DART AEROSPACE LTD	Work Order:	88002
Description: Crosstube Assembly, Mid Aft	Part Number:	D206-667-247TRN
Inspection Dwg: D206-667-247 Rev: A		Page 1 of 2

DRAWING NO. D206-667-247	TITLE CROSSTUBE ASS'Y (206L MID AFT)	REV. A	DART AEROSPACE LTD ENGINEERING ORDER	D.E.O. NO. D206-667-247-A-1	SHEET NO. SHEET 1 OF 1	SCALE NTS
DRAWN <i>qp</i>	CHECKED <i>ASS</i>	MFG. APPR. <i>AB</i>	APPROVED <i>JWD</i>	DE APPR. <i>#</i>		
DATE 11.07.15	DATE 11.07.20	DATE 11.07.21	DATE 11.07.21	DATE 11.07.21	DATE 11.07.21

PURPOSE:

REPLACE MAGNOBOND WITH PROSEAL.

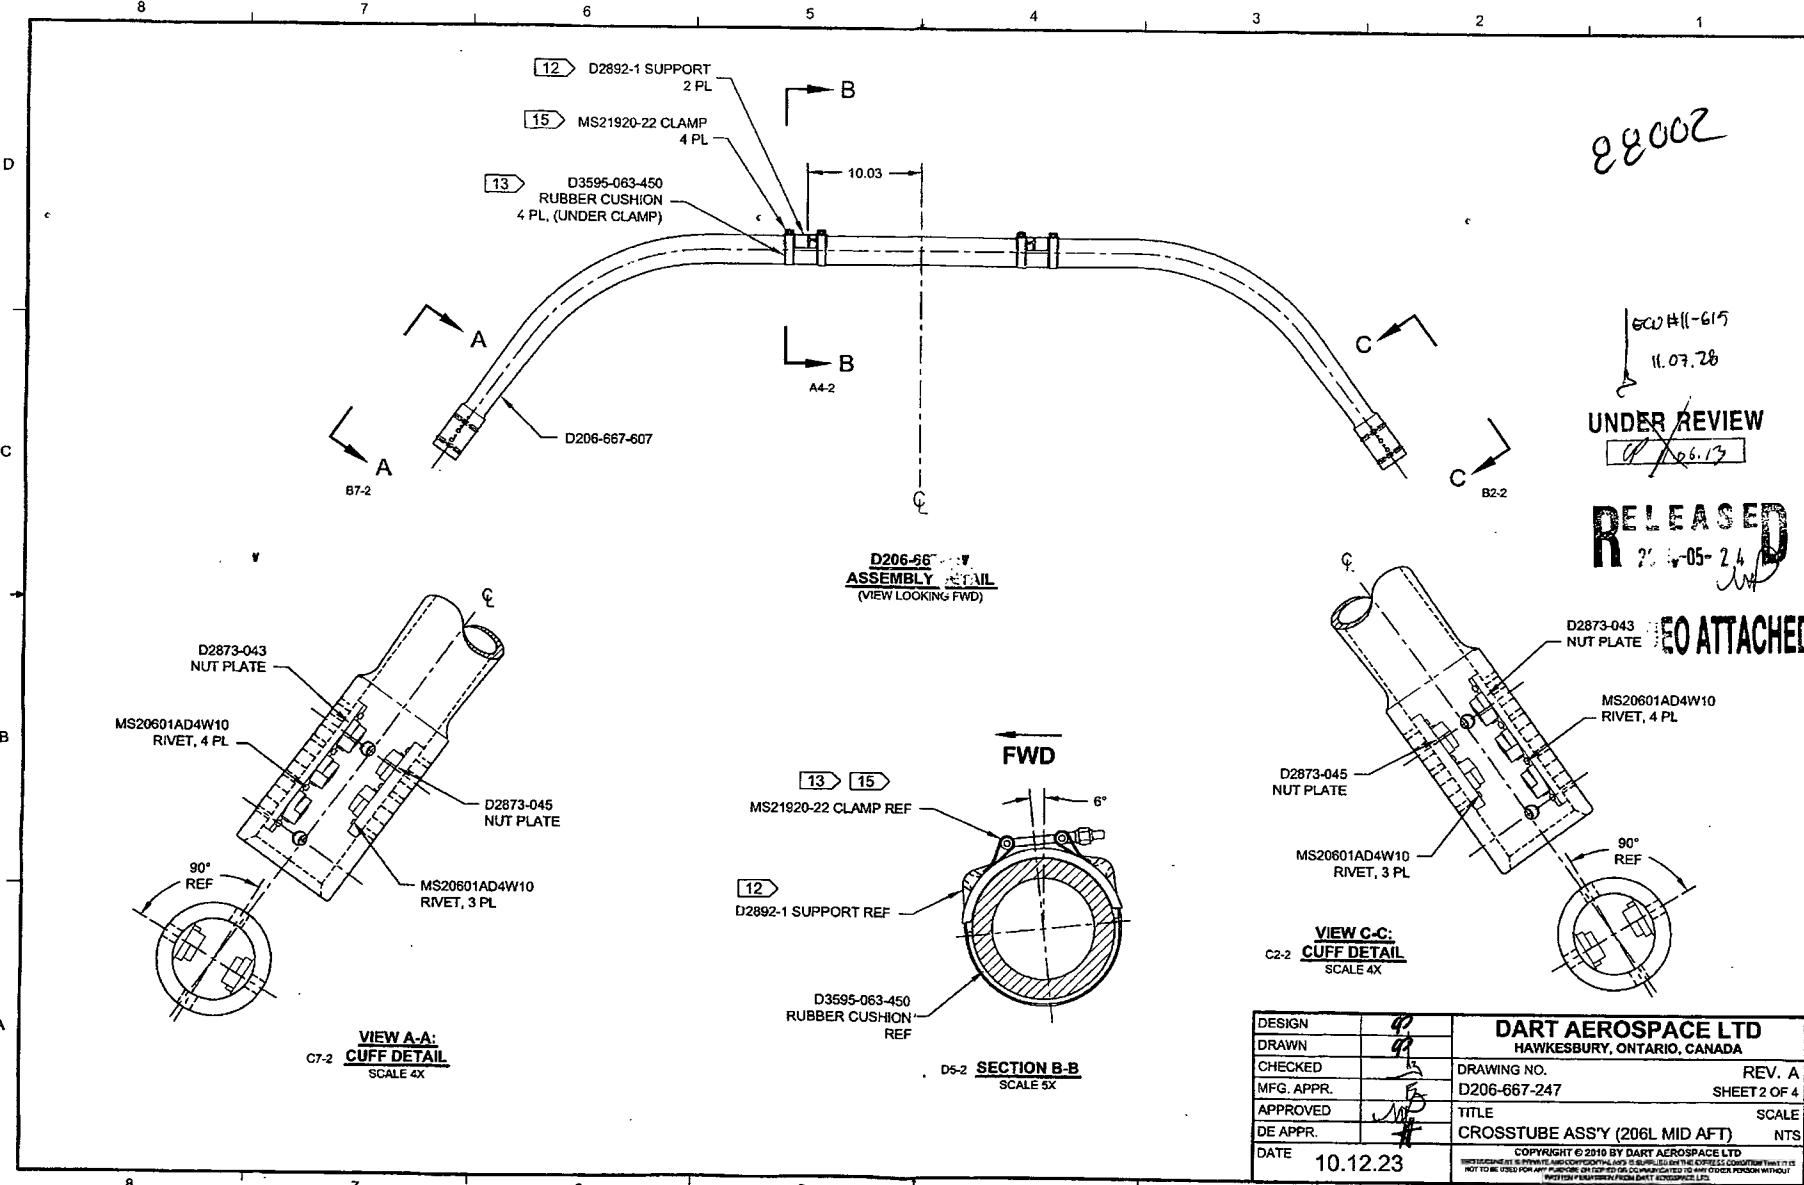
NOTE 12 & 15, SHEET 1 IS AMENDED AS FOLLOWS:

Item	Qty	Part Number	Description
9	A/R	PROSEAL 890 B-2	SEALANT, AMS-S-8802 CLASS B-2

12) TO INSTALL D2892-1 SUPPORT: ABRADE MATING SURFACE OF SUPPORT AND CROSSTUBE WITH 180-GRIT SANDPAPER AND REMOVE RESIDUE WITH MEK (OR EQUIVALENT). APPLY A 0.04" TO 0.07" THICK LAYER OF PROSEAL 890 CLASS B-2 (OR AMS-S-8802 CLASS B-2) SEALANT TO MATING SURFACE OF SUPPORT.

15) TORQUE CLAMPS 80 TO 100 IN-LB. ENSURE AT LEAST 1.5 THREADS SHOWING IN SAFETY AND THAT NUT HAS NOT BOTTOMED-OUT AFTER TORQUING. PRIOR TO PACKAGING, RE-CHECK TORQUE ON CLAMPS AFTER PROSEAL 890 SEALANT HAS CURED FOR 72 HOURS.
